CENTERVILLE CITY PLANNING COMMISSION AGENDA

**STAFF REPORT
AGENDA: ITEM 1**

**STAFF REPORT
AGENDA: ITEM 3**

SITE PLAN / WASATCH RUNNING CENTER CENTERVILLE, UTAH

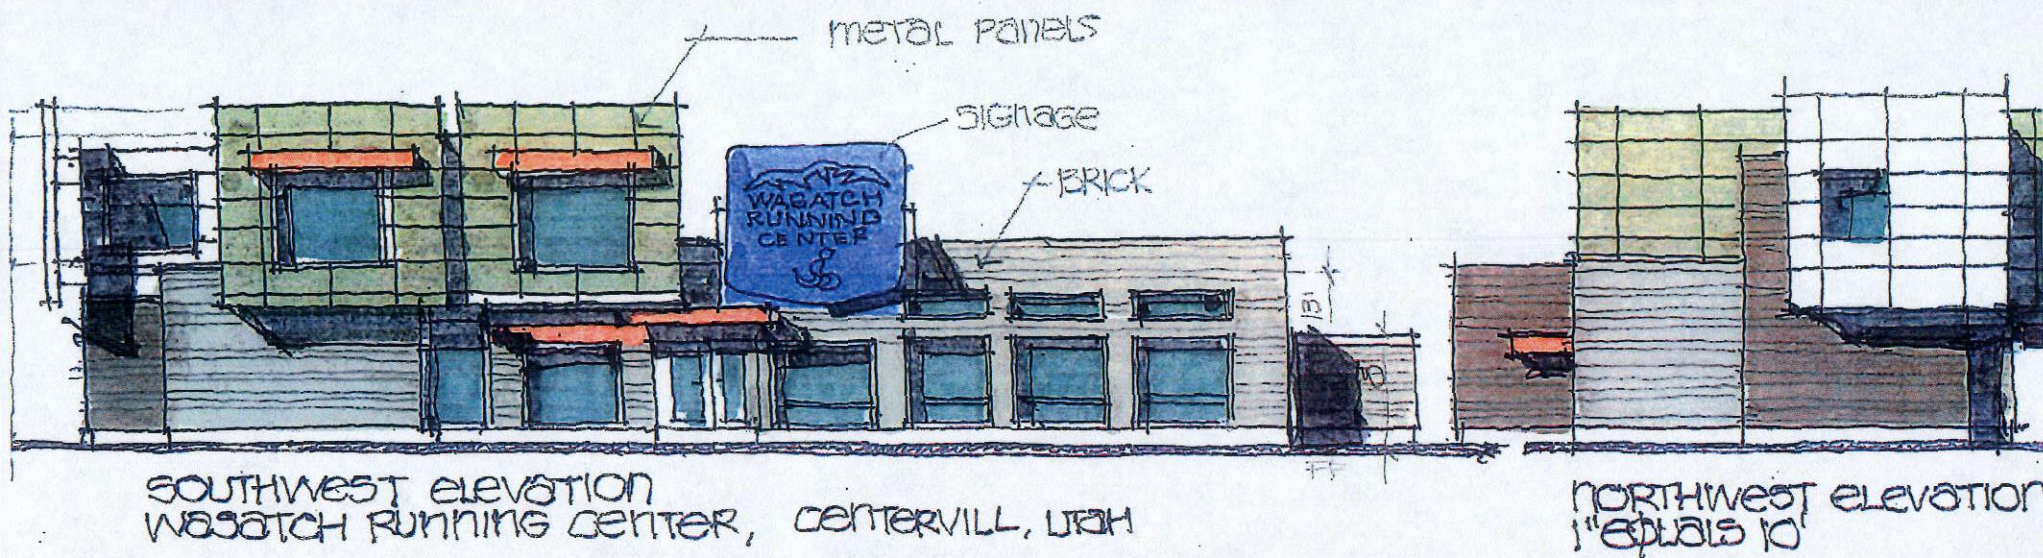
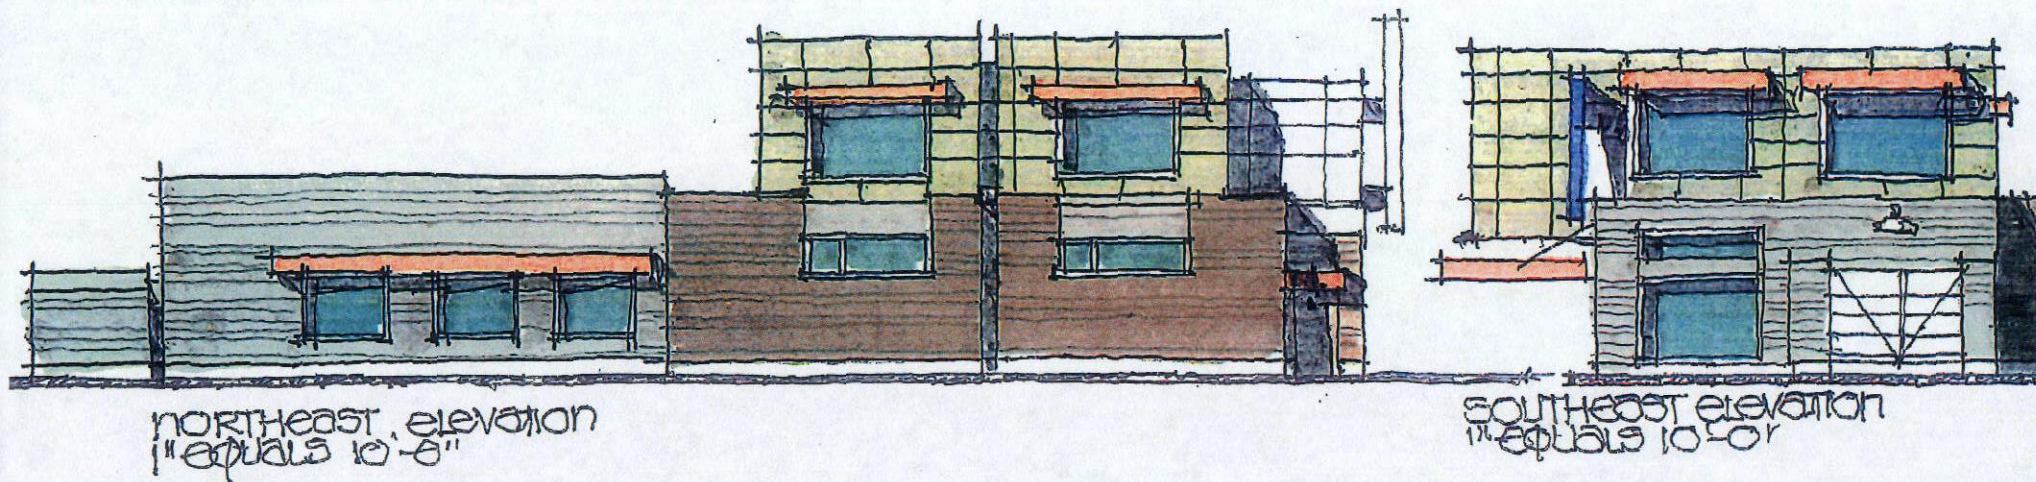
- Staff Response: The building design is very contemporary with a neo-modern design. The structure has been drawn with rectangular forms, straight lines and square bump outs. The articulation is designed in such a way that does not only give architectural relief to the pedestrians but all vehicles traveling on Marketplace Drive, the Frontage Road and Parrish Lane. The applicant has also included a pathway from the sidewalk to the front of the building. They have also connected this path to the crosswalk in the parking lot that connects to Iggy’s that has already been put in place.

- Staff response: The site plan does not indicate any public amenities except for the pathway to the sidewalk. Staff would suggest the applicant look at a few options such as benches in front of his store, or an outdoor drinking fountain for runners, walkers and bikers that are passing by or visiting the establishment. The building does have a front canopy and appears to have addressed ADA accessible requirements. Staff also requests that on the outside of the building, decorative lighting be added that draws attention to the modern straight-line style of the building.

- Staff Response: Elevations were submitted, yet according to Section 12-63-040(c)(1), a storyboard is required as part of review for the final site plan approval. As mentioned previously the building has a very unique architectural design. The use of glass, panelized rain screen (outer aluminum wall

- Staff Response: The applicant has indicated the location of parking stalls, drive isles and parking lot islands, that meet and exceed the minimum requirements found in Chapter 12-52 of the Ordinance. The final site plans will need to show the percentage of parking lot landscaping, which must be 7% of the total parking lot area [12-51-070(e)(1)(B)], and the types of vegetation to be planted. As a reminder, they will need to have one tree and two shrubs planted for every six required parking stalls. With the street side berming, landscaping and trees. All ingress and egress has already been constructed with the Iggy's development

1. All parking stalls shall be reduced to 9' x 18' to meet City Standards.
2. A soils report shall be submitted to City staff for review and approval as part of the final site plan application.

5. Public amenities, such as a bench or outside drinking fountain should be considered to enhance the pedestrian experience.
6. To emphasize the unique architecture of the building, decorative lighting should be added to the building.

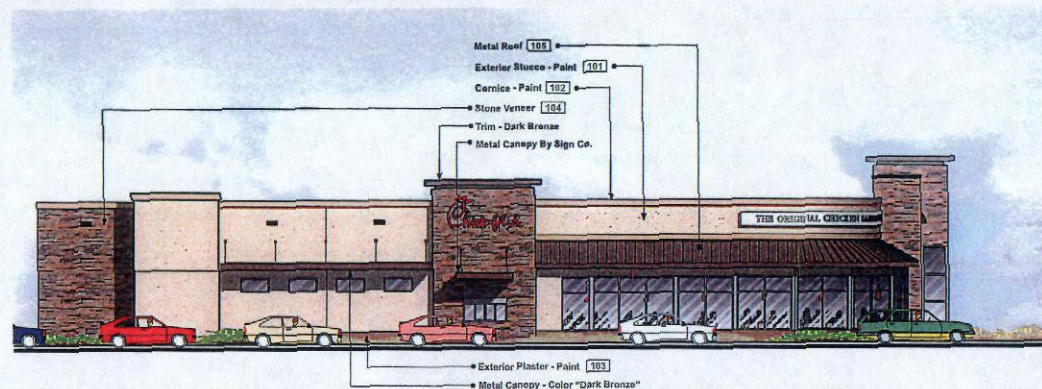
- **Staff Response:** The submitted plans address this issue by showing the elevation schematic of the building. The elevation design of the structure uses the stepping design horizontally and vertically by having towers above the main entrances. This has provided a visual relief in the total mass of the building. In addition, the plans depict a pedestrian pathway directly from the sidewalk to the main entrance of the business. This pathway will need to be five feet wide and consist of colored concrete to give a visual difference between the space for pedestrians and vehicles.

➤ **Staff Response:** Building elevations were submitted listing colors and materials, however, according to Section 12-63-040(c)(1), a storyboard is required as part of review for construction within the Parrish Lane Gateway area. The applicant will need to submit this information as part of the final site plan application.
